Ref. No. 201408054  
Petition No. 374Rev.

- REQUEST TO TEMPORARY CLOSED STREET

| <b>B</b>  |                                   |          |          |      |          | <b>REQUEST TO TEMPORARY CLOSED<br/>         A PORTION OF SCOTTEN AVE. 780 FT. 66 FT. WD.<br/>         IN THE BLOCK BOUND BY<br/>         CLARK, MICHIGAN AVE., MICHIGAN CENTRAL R.R.<br/>         AND NEW YORK CITY R.R.</b> | <b>CITY OF DETROIT<br/>         CITY ENGINEERING DEPARTMENT<br/>         SURVEY BUREAU</b> |                      |

PETITION NO. 374  
 GENERAL DEVELOPMENT COMPANY LLC  
 C/O CHRYSLER CORPORATION  
 TWO TOWER SQUARE, SUITE 850  
 SOUTHFIELD, MICHIGAN 48078  
 C/O BRUCE BRICKMAN  
 PHONE NO. 248 514-7111

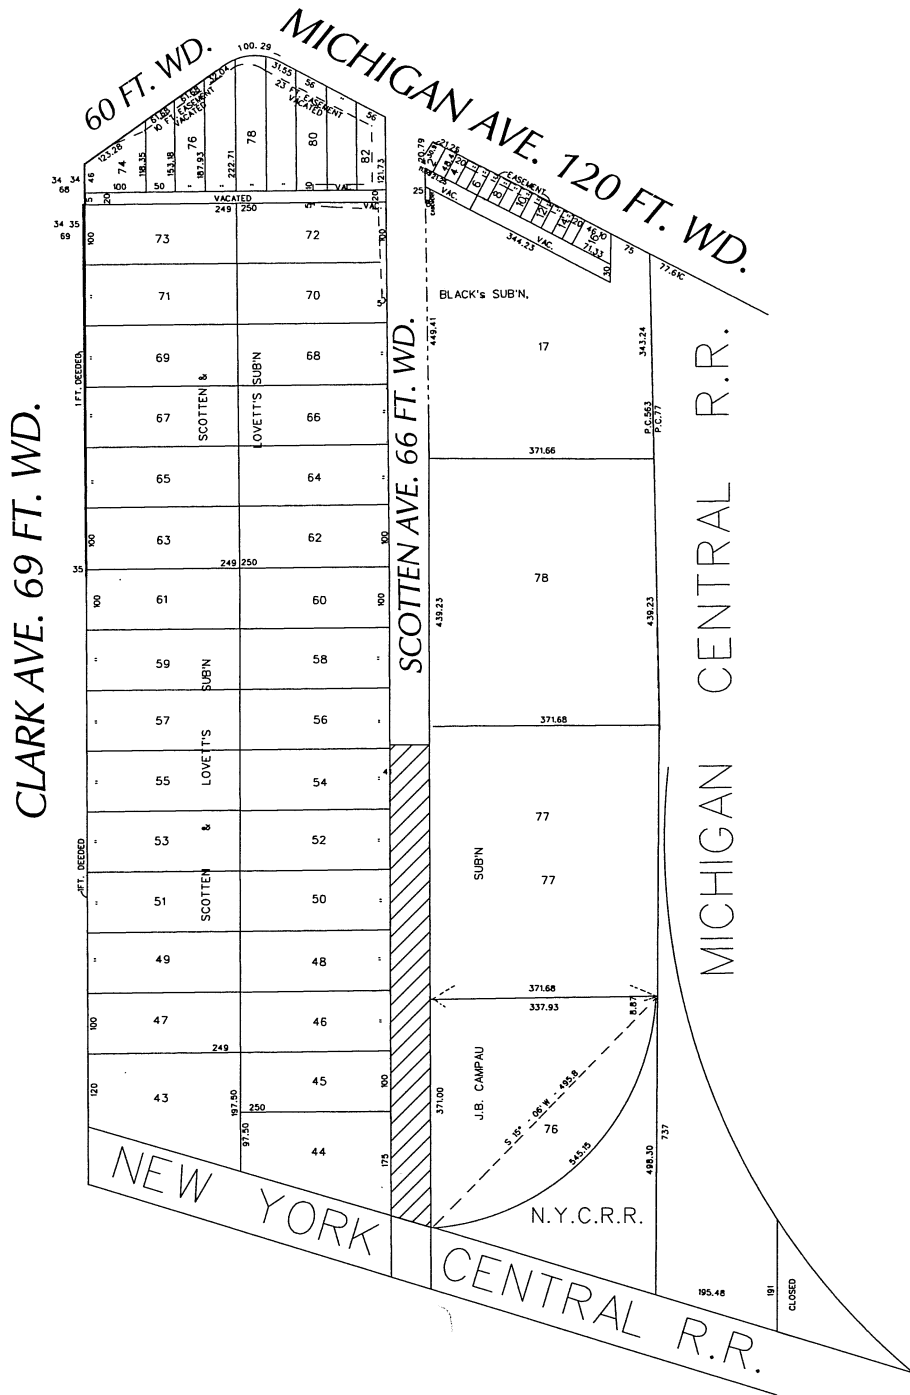
- ( ) Involved; the nature of our services, and the estimated costs of removing and/or rerouting such services are:
- (x) Involved; have no objection to temporarily close a portion of Scotten Avenue 780 ft 66 ft wide in the block bound by Clark, Michigan Ave., Michigan Central R.R. and New York City R.R. as shown on drawing no. x374 dated 08/20/2014 and revised on 10/02/2014 provided that the following conditions are met with:

- (1) Petitioner/developer shall be responsible to maintain proper building set-back clearance from the Scotten Ave. Right of Way.
  - (2) 100 % signatures of abutting and affected property owners shall be secured.

- (3) Petitioner/developer shall be responsible to restore the street to its original condition if and when requested by the City.
  - (4) Petitioner/developer shall be responsible to construct a vehicle turn around/ cul de sac for SB Scotten just north of the temporary closed portion and another for NB Scotten just south of the New York Central RR. The said turn around/ cul de sacs shall be constructed prior to the temporary closing of the street after seeking necessary approval for the geometric design of the turn around/ cul de sacs from Traffic Engineering Division.
